**PAUL HALAJIAN
ARCHITECTS**

ADDENDUM

PROJECT: **Clovis Landmark Square
Senior Activity Center and Transit Center**

ADDENDUM#: **03**

DETAIL 8
SCALE: 1" = 1'-0"
RF116 S509

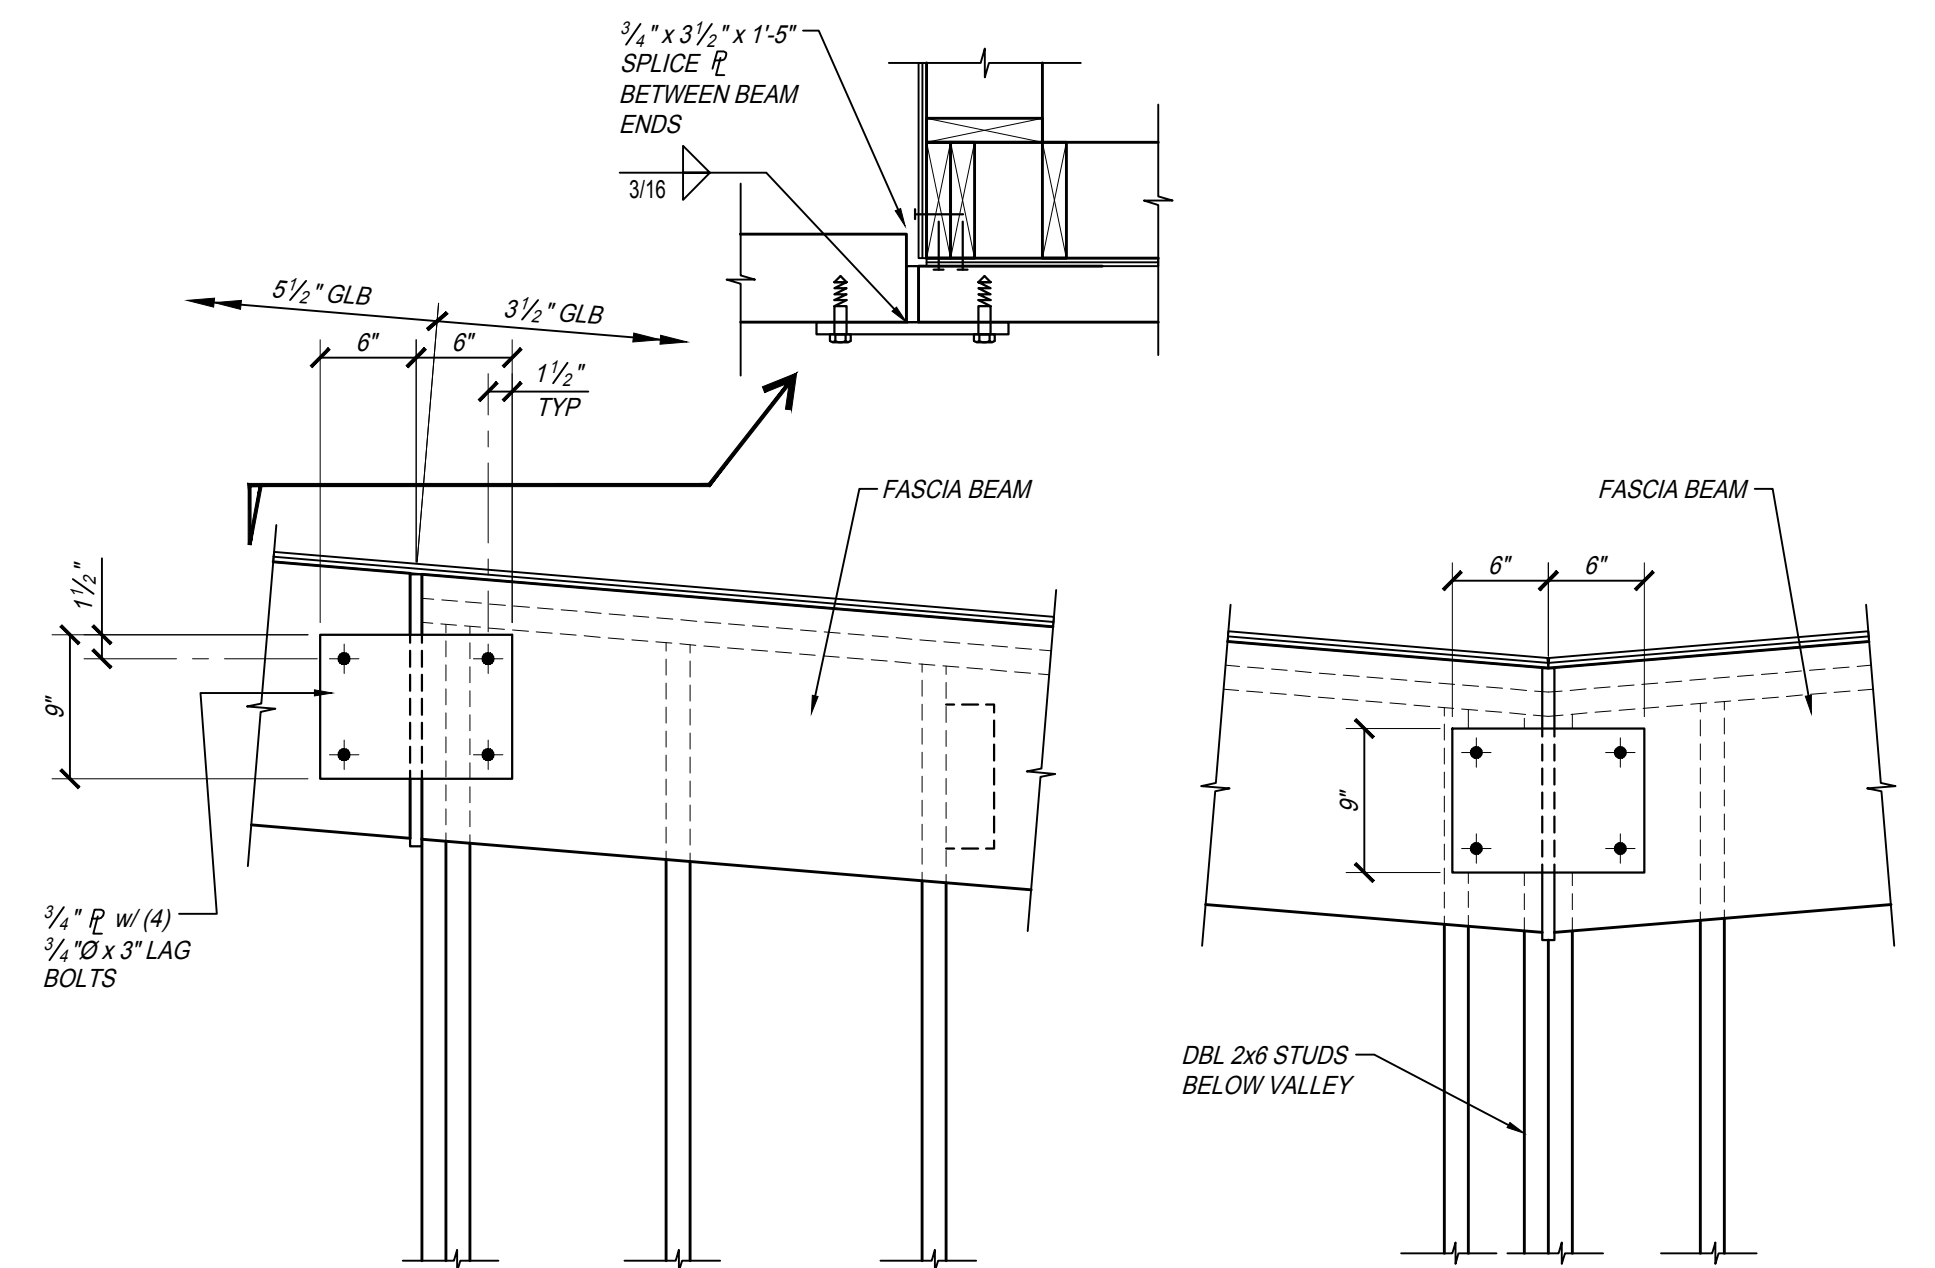
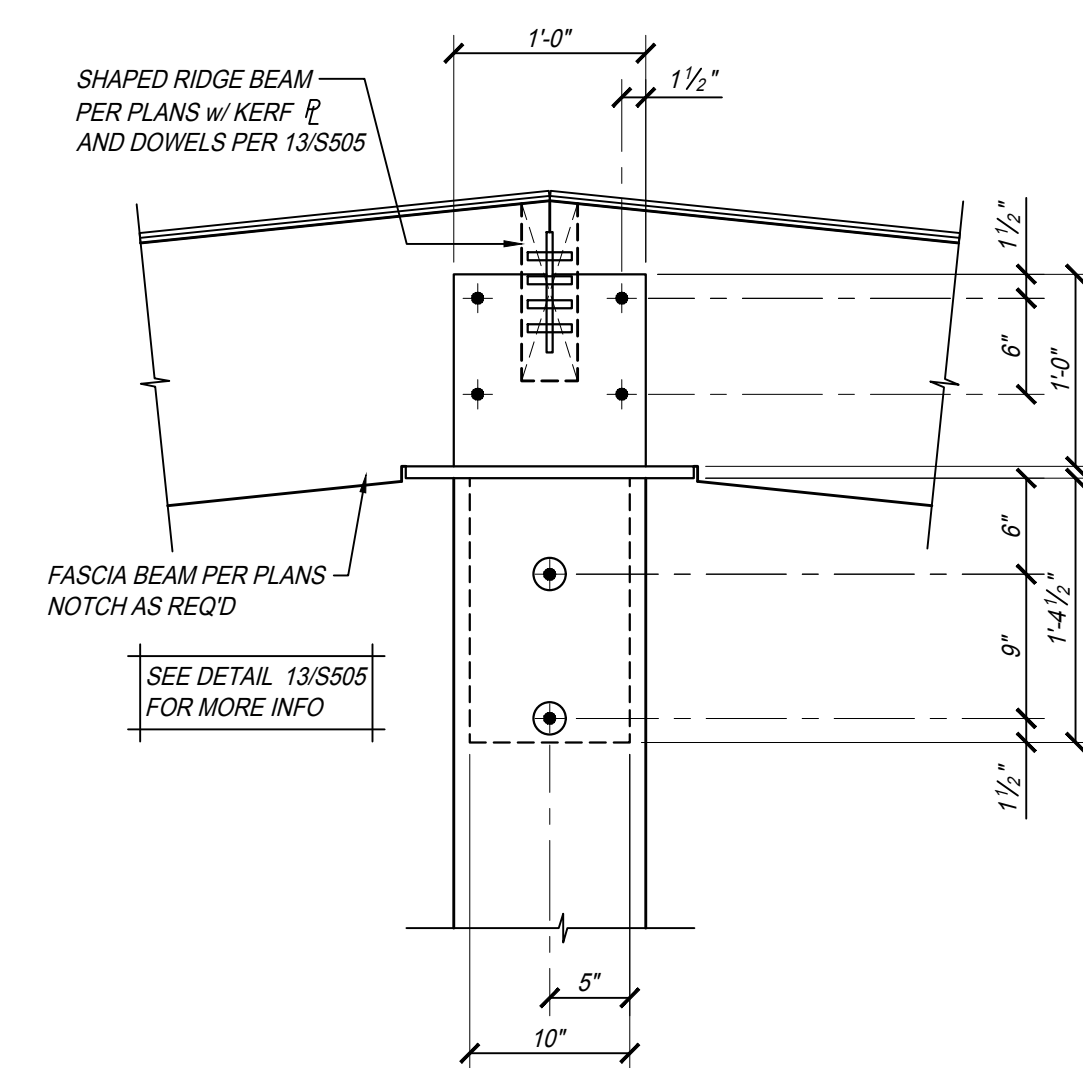
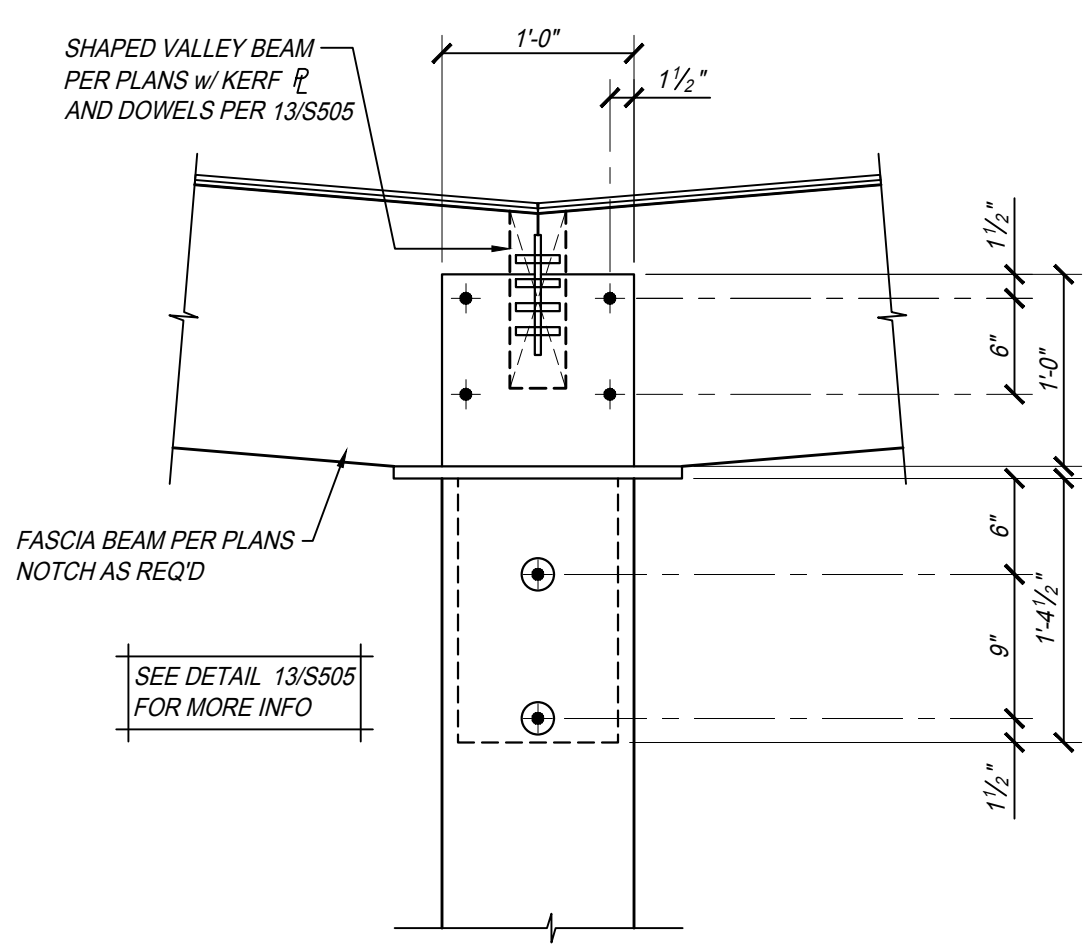
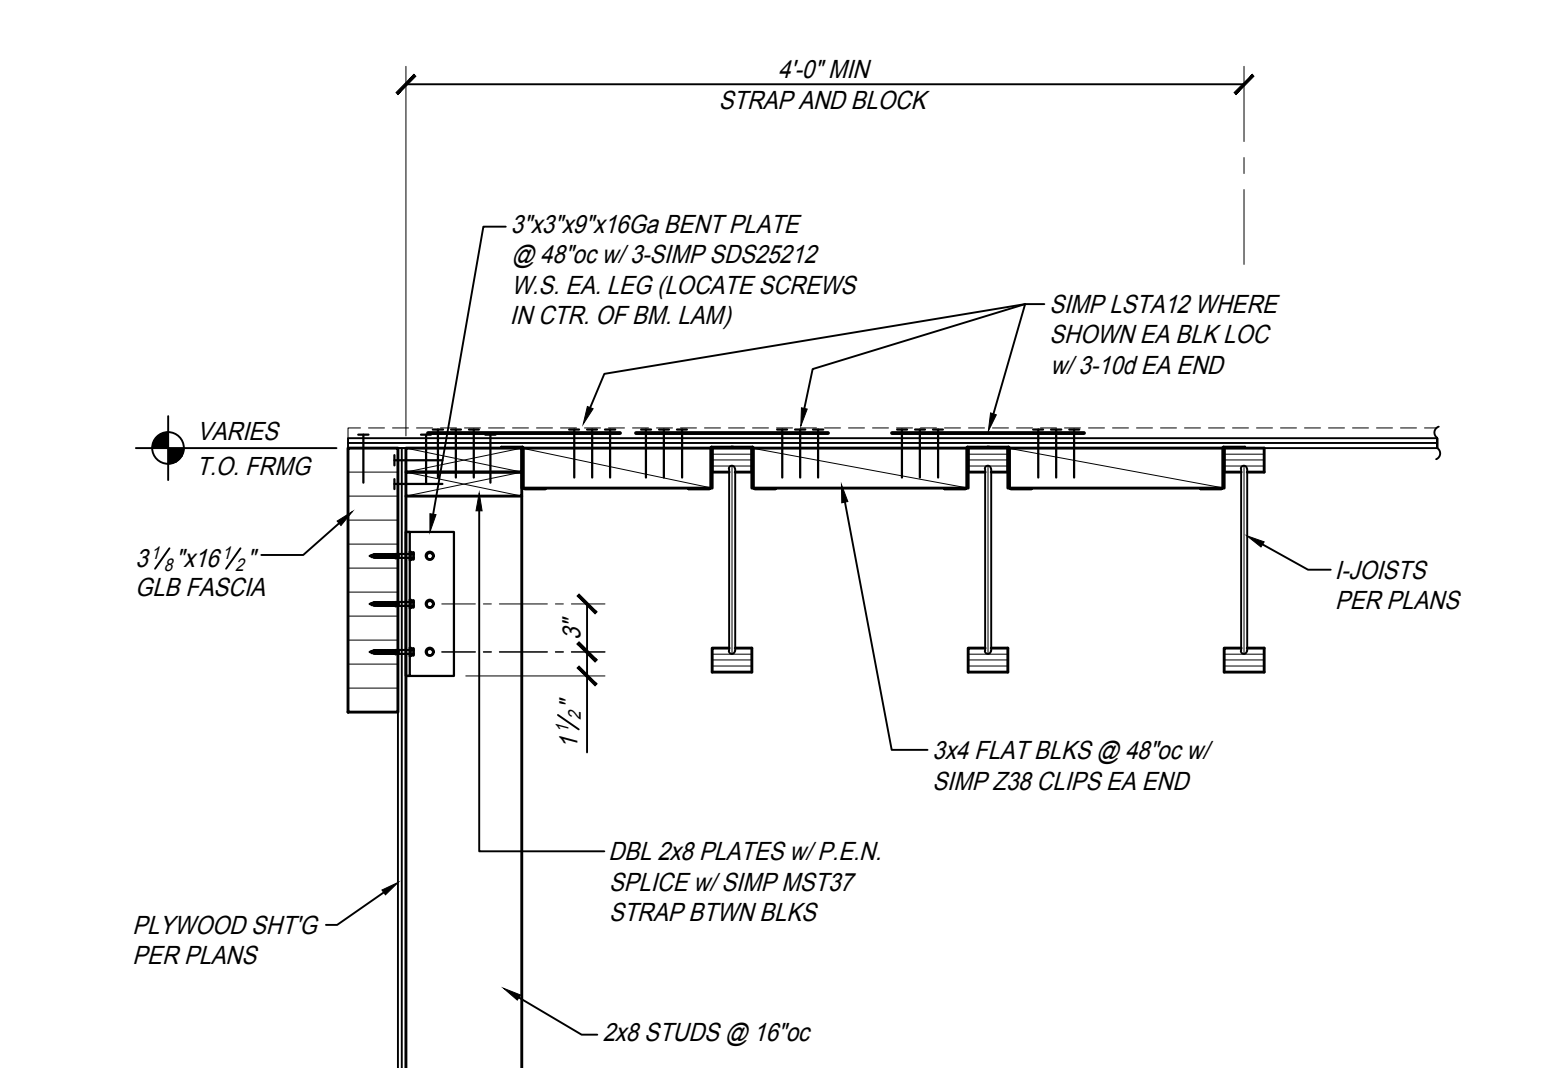
- a. Omit sheet **AD1-S509, Roof Framing Details** and replace with **AD3-S509, Roof Framing Details** attached. The following changes have been made:
 - i. See detail 8/S509 – Revised Plan View detail so it is fully shown.
 - ii. See detail 9/S509 – Revised spacing of All-Thread rods to beams.
 - iii. See detail 10/S509 – Revised spacing of All-Thread rods to beams.

DETAIL 6
 SCALE: 1" = 1'-0"
 BM1 S603

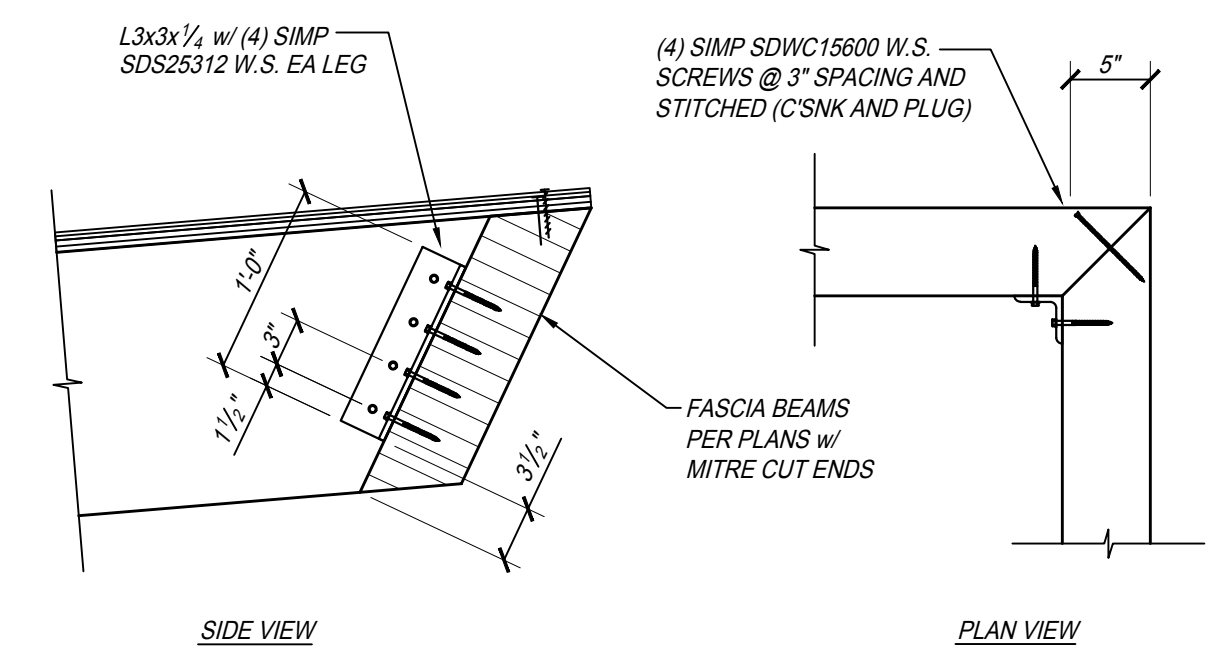
- a. Omit sheet **AD2-S603, Beam Details** and replace with **AD3-S603, Beam Details** attached. The following changes have been made:
 - i. See detail 6/S603 – Revised detail. This is the typical fascia corner condition.
